**NRC COMMENTS ON LANL REPORT  
"STATUS OF VOLCANIC HAZARD STUDIES  
FOR THE YUCCA MOUNTAIN SITE  
CHARACTERIZATION PROJECT"**

**JOHN TRAPP, NRC  
JUNE 9, 1993**

Comments on:

# ***DOE-NRC Technical Exchange on Volcanism Studies***

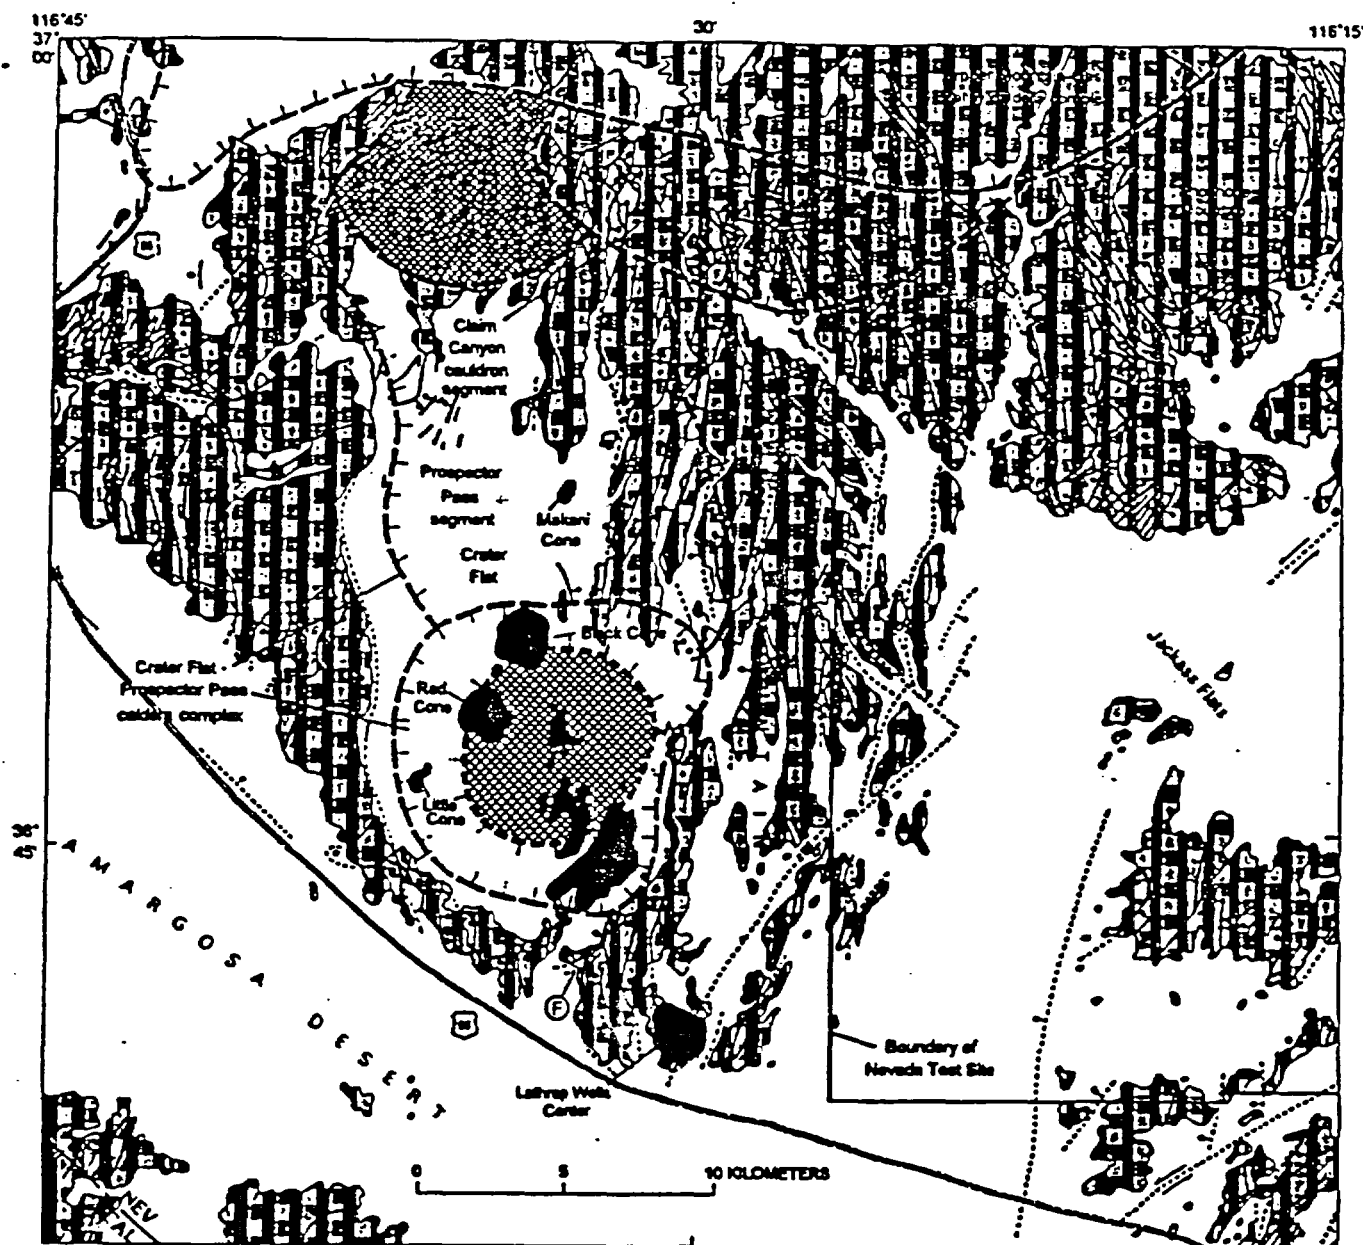
**IT IS UNCLEAR HOW THE PROPOSED TIME SPACE PATTERN OF VOLCANISM CAN BE EXPLAINED IN THE CONTEXT OF THE CALDERA MODELS, THE RIFT MODELS, THE PULL-APART MODELS, DETACHMENT MODELS, ETC.**

**IT IS UNCLEAR WHAT RELATIONSHIP THERE IS BETWEEN THE MODELS PROPOSED IN CHAPTER III AND THE PROBABILITIES CALCULATED IN CHAPTER VII.?**

Map outlining the AMRV (dashed line) and high-risk zones (rectangles) in the Yucca Mountain (YM) area that include Lathrop Wells (LW), Sleeping Butte cones (SB), Buckboard Mesa center (BM), volcanic centers within Crater Flat (CF). (Source: Smith et al., 1990a, fig. 7)

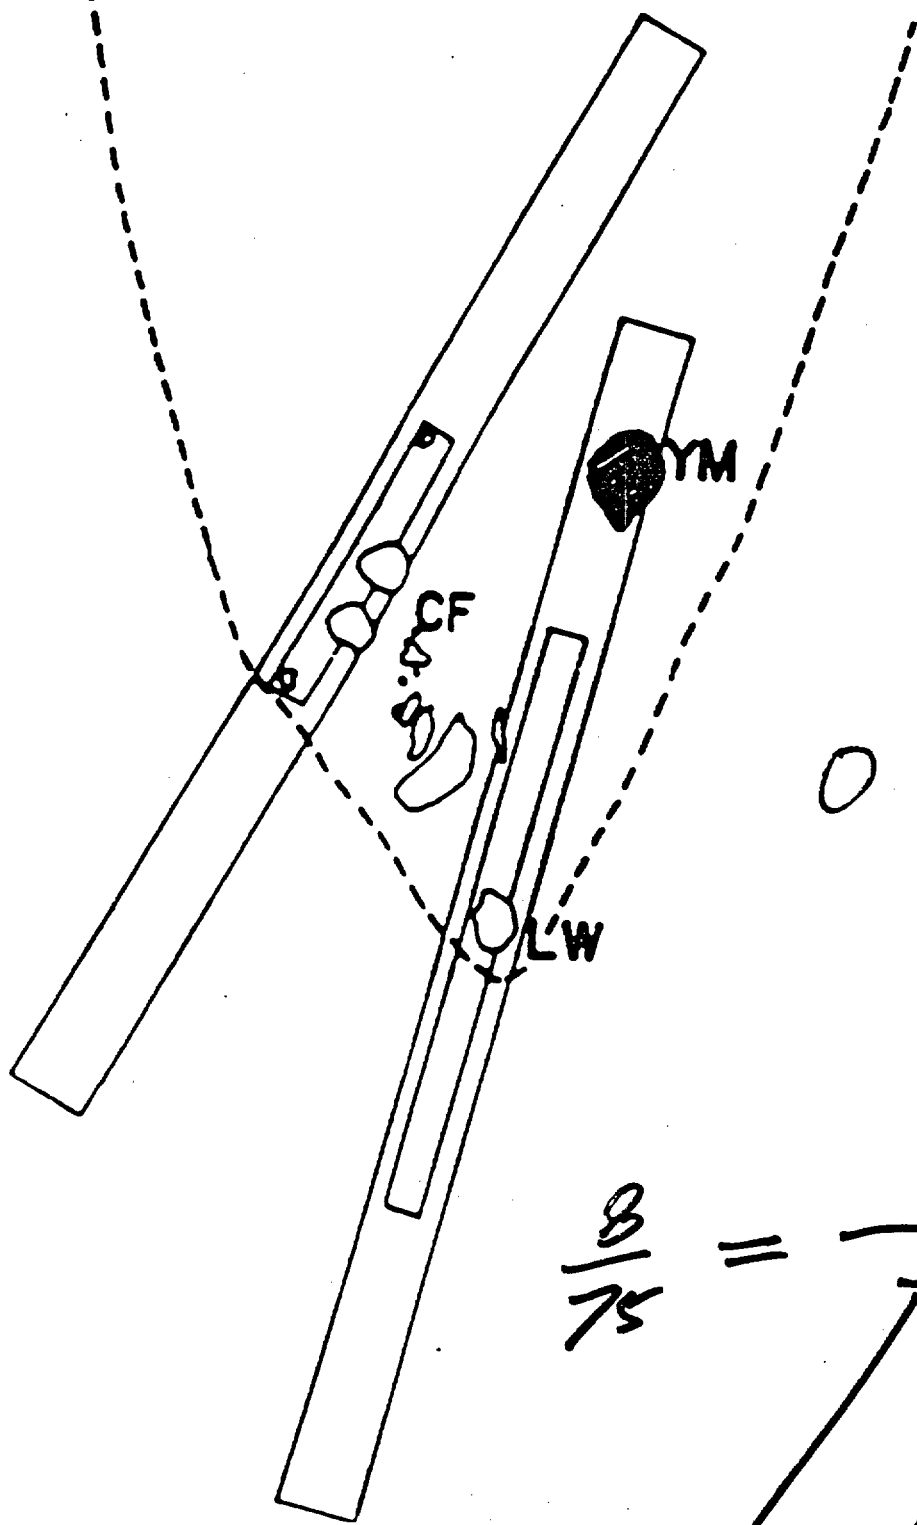
The technical machinery (Bayesian approach) involved in the risk calculation would support much more informative answers if the prior distribution  $\pi(p)$  is adequately chosen.

1.  $A = 75 \text{ km}^2$  (= half of the rectangle)
2.  $a = 8 \text{ km}^2$  (area of the repository,  
Crowe et al, 1982)
3.  $\pi(p) \sim U(0, 8/75)$ , which assumes  
8/75 as the upper limit for  $p$
